UNITED STATES PATENT AND TRADEMARK OFFICE

APPLICATION NO.	FILING DATE	FIRST NAMED INVENTOR	ATTORNEY DOCKET NO.	CONFIRMATION NO.
09/867,382	05/31/2001	John F. Shanley	032304-020	7984

Office Action Summary

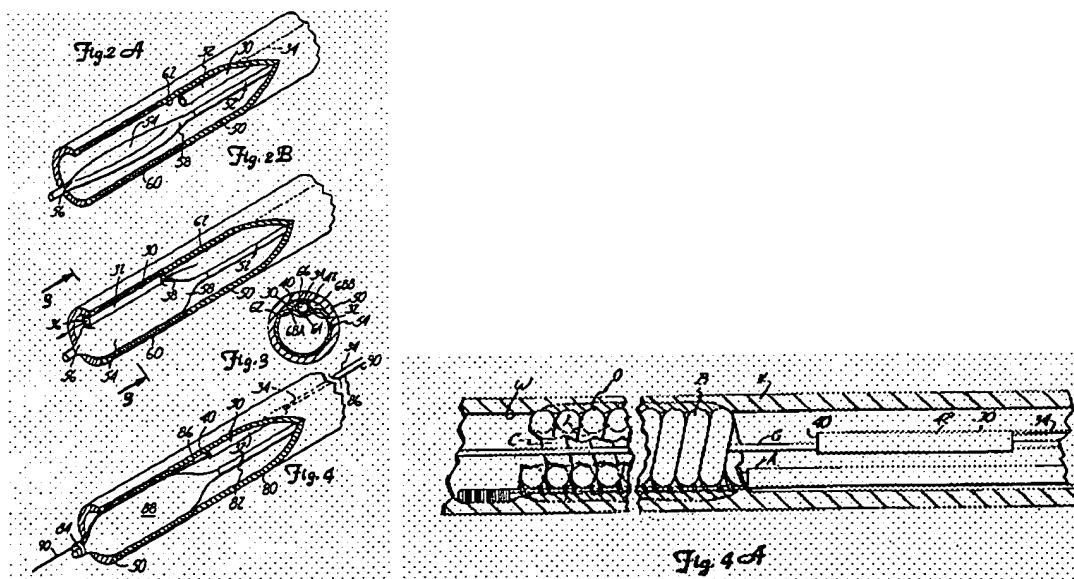
Claim 23 is rejected under 35 U.S.C. 102(b) as being anticipated by **Cox**.

The Cox Patent shows in the figures above, a catheter with an inflatable balloon, a guide member, and a branch lumen guidewire extending along an exterior of the balloon and longitudinally slidable in the guide member.
